RESPONSE TO AN OPEN (ACTION) ITEM FROM THE APRIL 14-15, 1987, MEETING BETWEEN THE NUCLEAR REGULATORY COMMISSION (NRC) AND THE DEPARTMENT OF ENERGY (DOE)

RESPONSE TO NRC-NNWSI PROJECT OPEN ITEM NO. 3
AND INFORMATION REQUEST IIIa

DRILLING AND BLASTING CONSTRUCTION METHODS THAT WILL BE USED IN ES-1 AND ES-2 OF THE ESF THAT WILL LIMIT THE DAMAGE TO THE WALL ROCK (WMPO ACTION ITEM: 87-1753)

TYPICAL SMOOTH BLASTING PATTERN

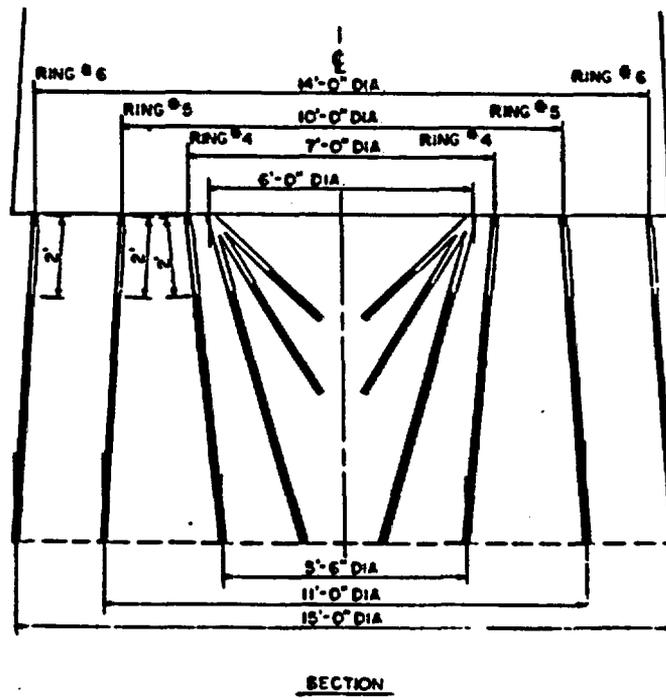
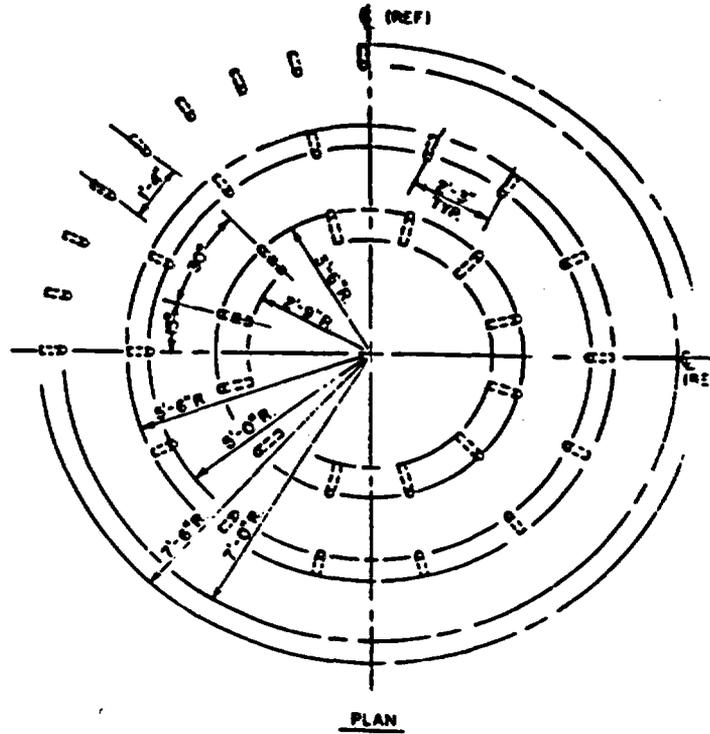
You must have a lower burden* compared to normal blasting for the rock to break successfully, since by design the compressive shock wave from the detonation within a smooth blasthole is lower and the impact of the expanding gases is lower than for normal blasting. Also, the spacing* between the perimeter holes must be reduced. The resultant shock waves from adjacent perimeter holes is believed to cause localized stress concentration in the rock and at the blasthole surface, and influence the direction and magnitude of a propagating fracture plane. Ideally, the end result is a plane of weakness which develops into a fracture between holes that outlines and limits the extent of the broken rock. The relationship of perimeter hole spacing to burden is critical to establishing a fracture plane between holes. The burden must be greater than the spacing between the holes. A burden/spacing ratio of 1.25 or greater is recommended. See Figure 1 for a typical smooth blasting pattern.
